ARCHITECHNICS, INC.
510 MAINE STREET
QUINCY, ILLINOIS 62301

ADDENDUM NO.: 1

ISSUED: 3/21/2024

Project: Roof Replacement
Meredosia-Chambersburg CUSD 11
830 Main Street
Meredosia, IL 62665

ROOF PLAN
 SCALE: 1/16" = 1'-0"

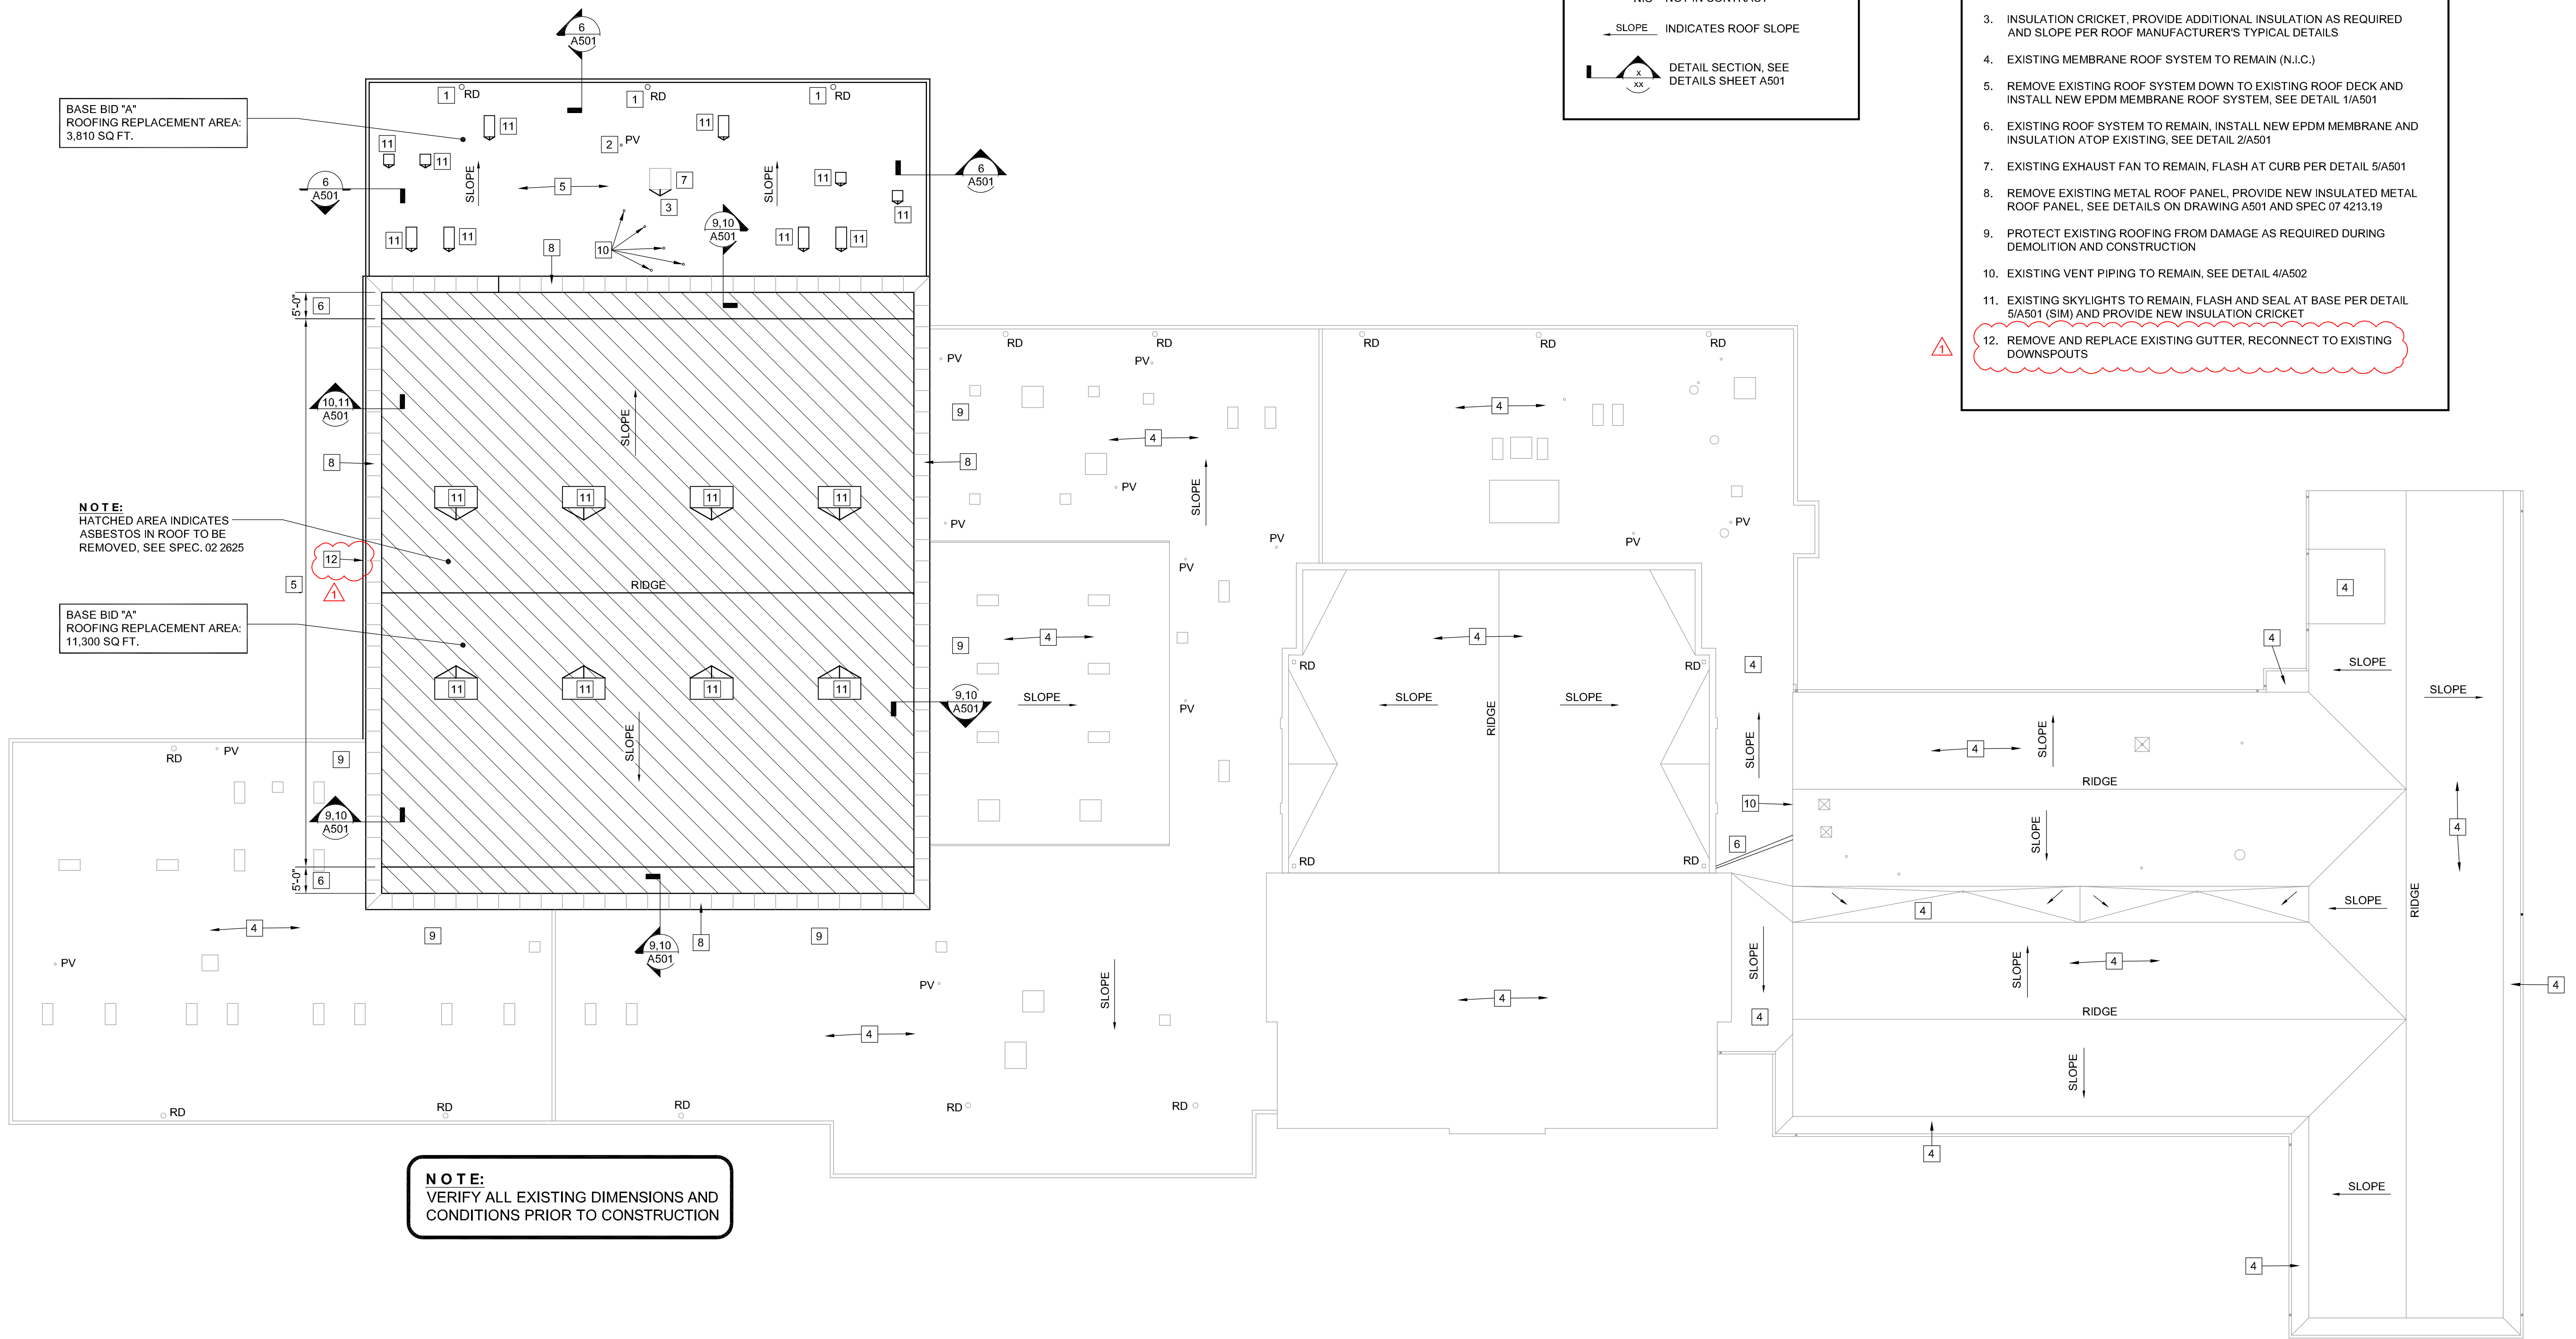
ITEM	DESCRIPTION
<u>Specifications</u>	
1.0 07 4213.19 Insulated Metal Wall Panels	Clarify Insulated metal panel shall be minimum R30.
2.0 07 5300, 07 5326 Elastomeric Roofing, Vapor Barrier	Add Membrane shall be manufacturers standard 60 mil. Provide 20 year total system standard manufacturer's warranty.
<u>Drawings</u>	
1.0 A101 Roof Plan	Add Added Keyed Construction Note #12 to remove and replace existing gutter at west side of gym roof.
2.0 A501 Details 9, 10, 11	Revise Details modified to show hat channel framing for panel support atop existing tectum deck. Detail 11 revised to show new gutter and flashing.
